State of Alaska  
Department of Fish and Game  
Nomination for Waters  
Important to Anadromous Fish

Anadromous Water Catalog Volume Revised March 12, 1987  
USGS Quad (41) Ketchikan Alaska (13-5)  
Name of Waterway Herring Cove Creek  
Anadromous Water Catalog Number of Waterway 101-45-10070

SUBJECT: Anadromous Stream  
Catalog

Proposed modification of  
Stream Catalog For Anadromous  
Stream # 101-45-10070 (Herring Cove)

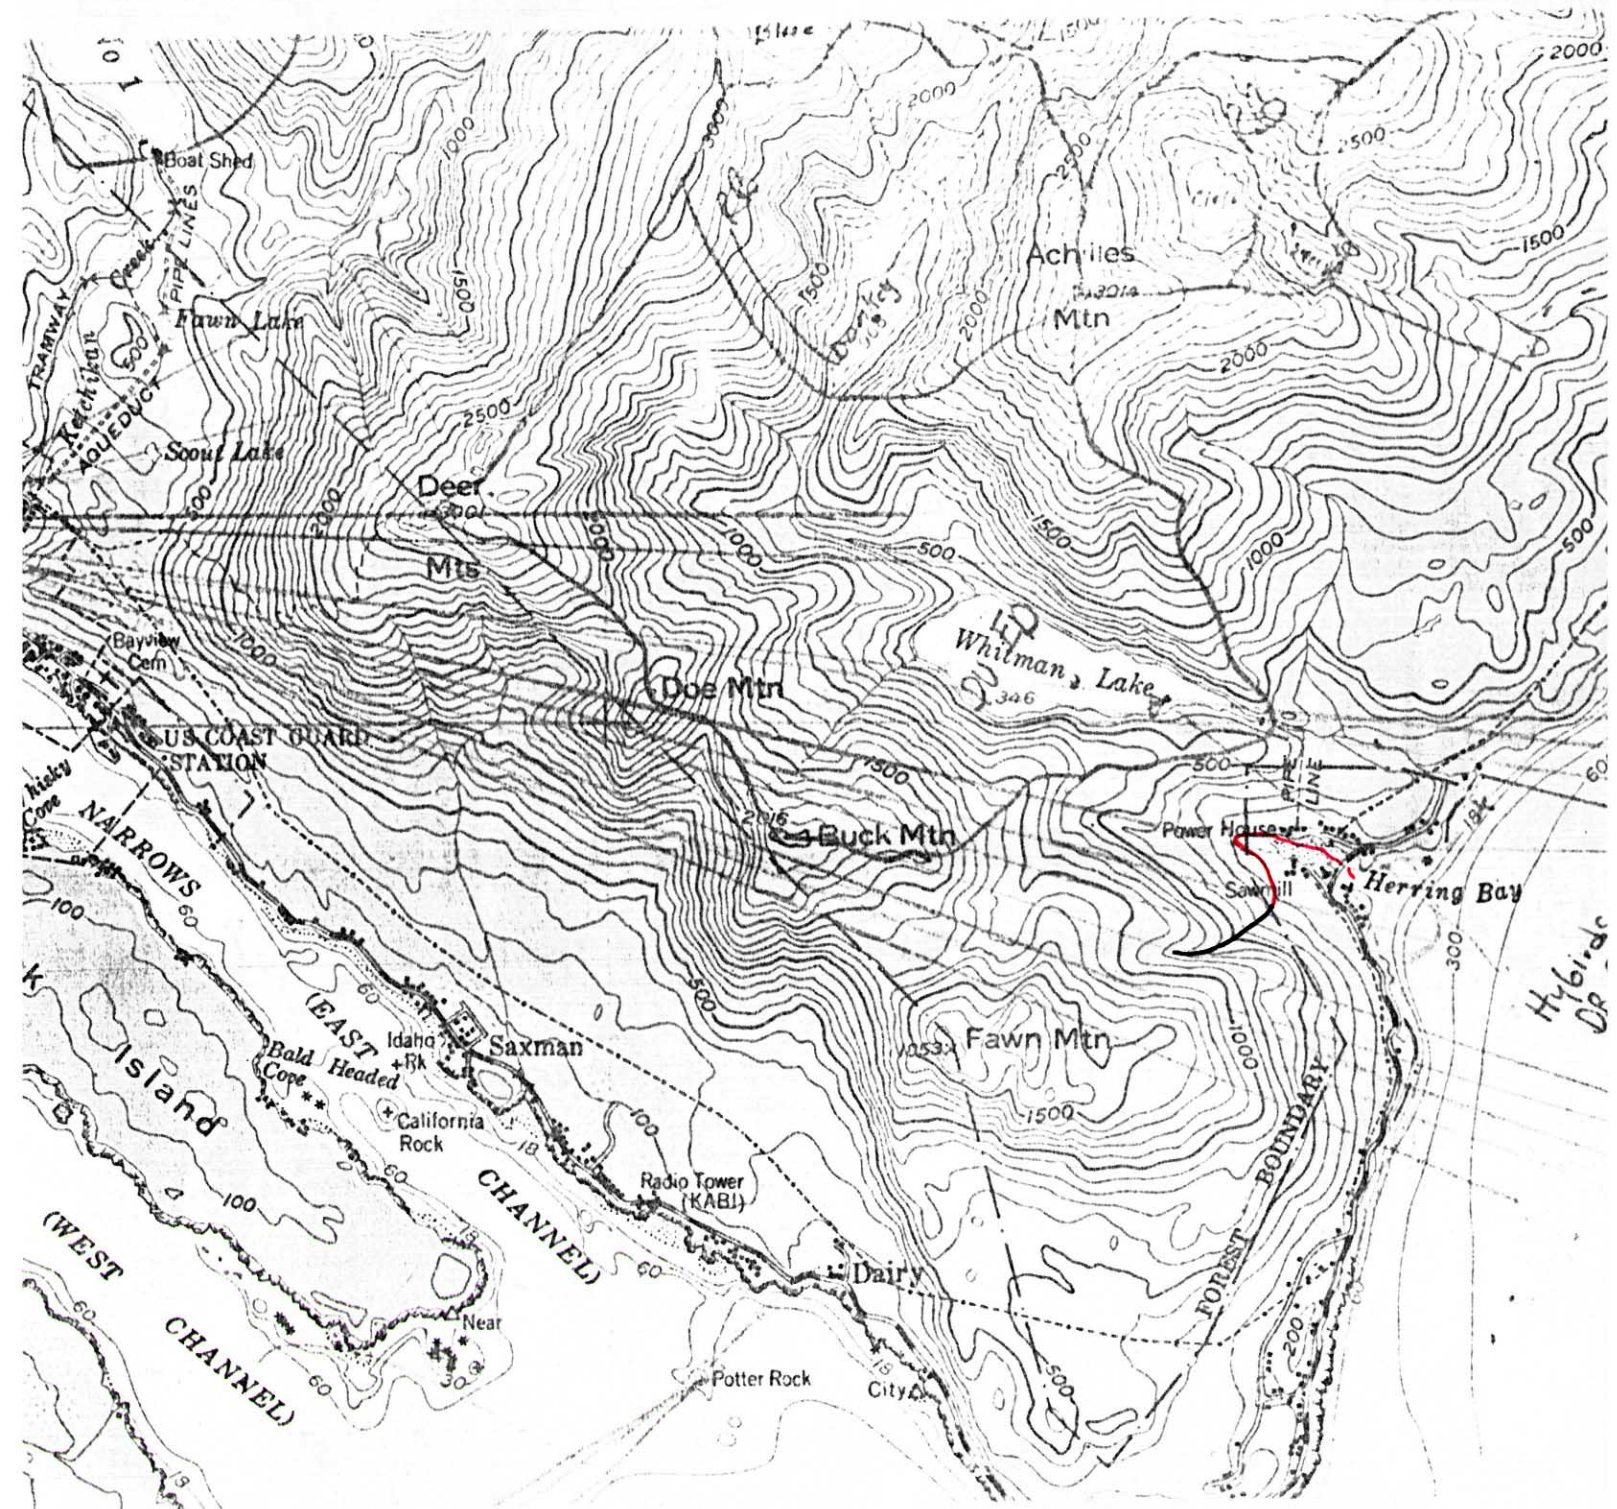
Stream is misplaced on map and is actually a main stream and tributary (see attached) draining separate watersheds.

A recent habitat issue has revealed an error in the current edition of the anadromous stream catalog. The error concerns Herring Cove Creek known to us as 101-45-007 and listed in the catalog as 101-45-10070 (Ketchikan B-6).

The stream, which appears to be misplaced on the topographical map, has a tributary which also contains anadromous fish, mainly pink salmon. In the stream catalog, the line depicting the stream is actually a combination of the main stream and tributary.

Enclosed is a copy of where the stream is presently indicated on the map in the stream catalog and its actual location as identified by recent ground surveys and an aerial photo. (The stream and tributary, though joining in the intertidal area, actually drain separate watersheds.) I would like to have this modification submitted for revision.
